BEAUMARIS CONCOURSE CAR PARK & STREETSCAPE WORKS BAYSIDE CITY COUNCIL LAYOUT PLAN- SHEET 1 of 2		SCALE @ A1	1:250	DRAWING No.:	18001 - 010	REV	4
FPA

**BEAUMARIS CONCOURSE**  
**CAR PARK & STREETSCAPE WORKS**  
 BAYSIDE CITY COUNCIL

**BEAUMARIS CONCOURSE**  
CAR PARK & STREETSCAPE WORKS  
BAYSIDE CITY COUNCIL  
PAVEMENT PLAN - SHEET 1 OF 2  
FLA  
DRAWN NO. 18001 - 200  
REV. 3

**BEAUMARIS CONCOURSE**  
CAR PARK & STREETSCAPE WORKS  
BAYSIDE CITY COUNCIL

**DRAINAGE LONGITUDINAL SECTIONS & PIT SCHEDULE**

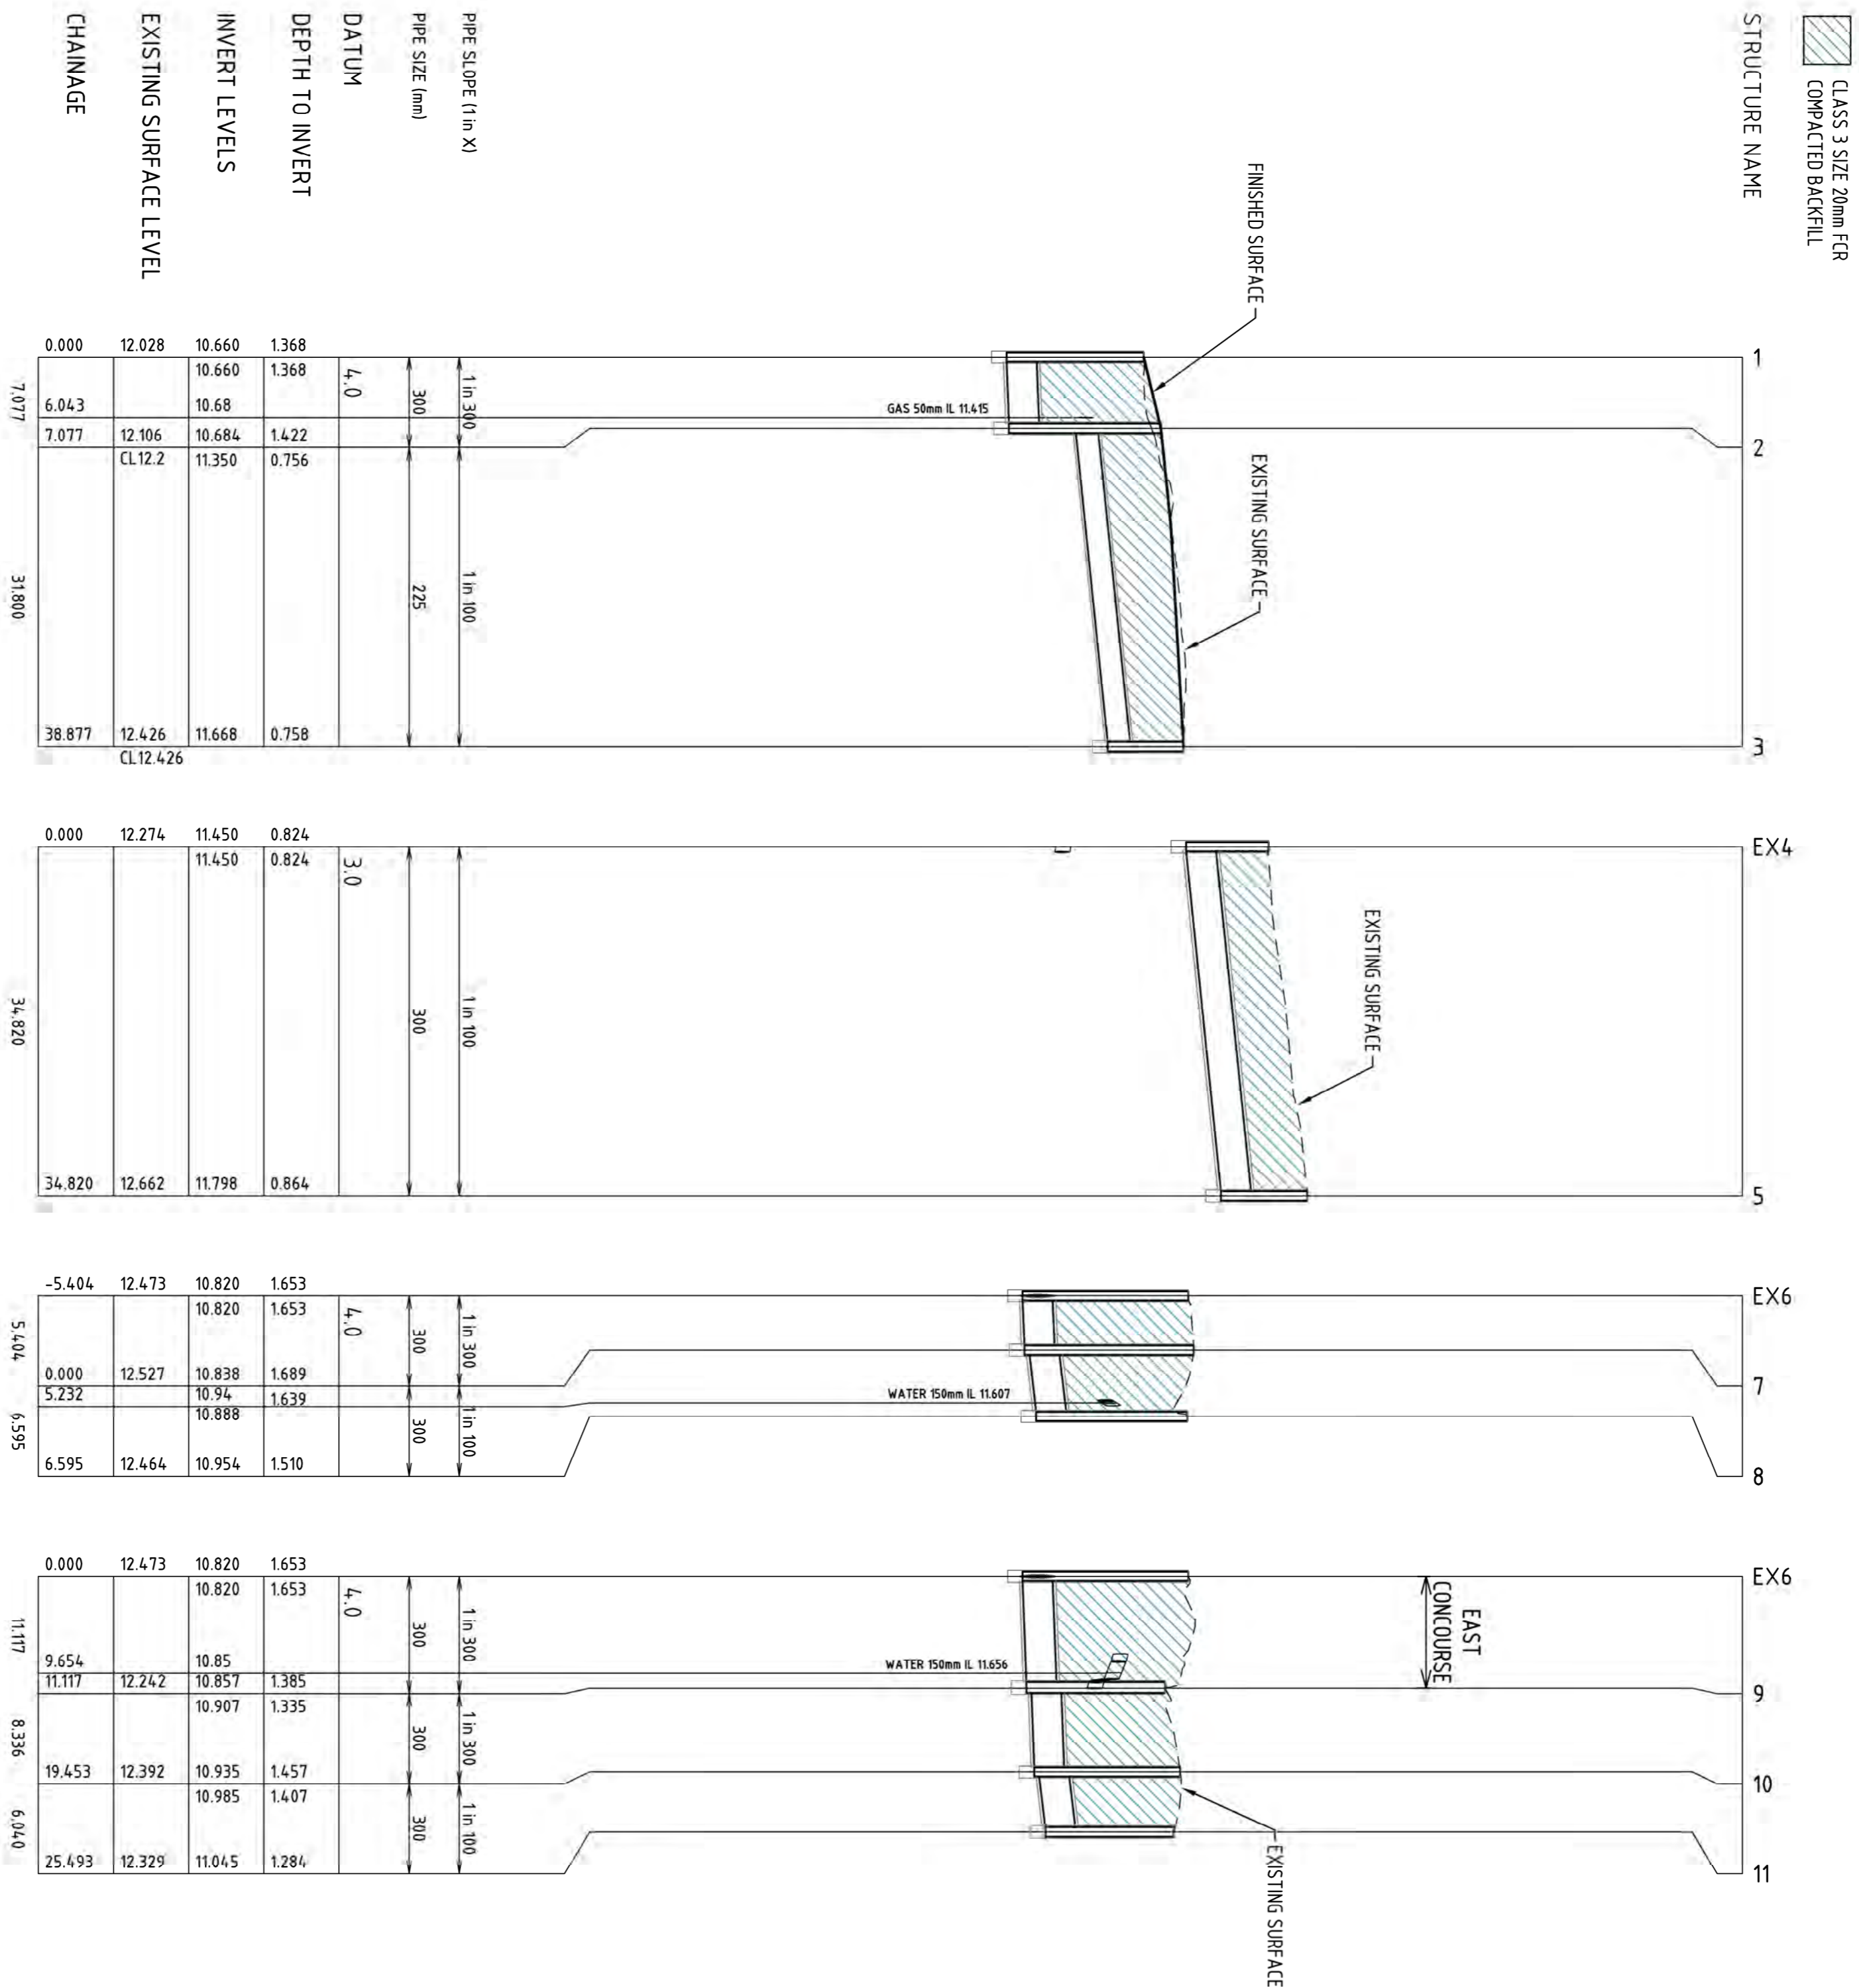
REV	DESCRIPTION	DWG NO	APPROVED	DRAWN	DATE
2	TENDER ADDENDUM - PIT 2 COVER LEVEL ADJUSTED	JW	NGP	MD	29/11/2018
1	ISSUED FOR TENDER	JW	NGP	MD	16/11/2018
0	PRELIMINARY ISSUE - NOT FOR CONSTRUCTION	JW	-	MD	12/11/2018
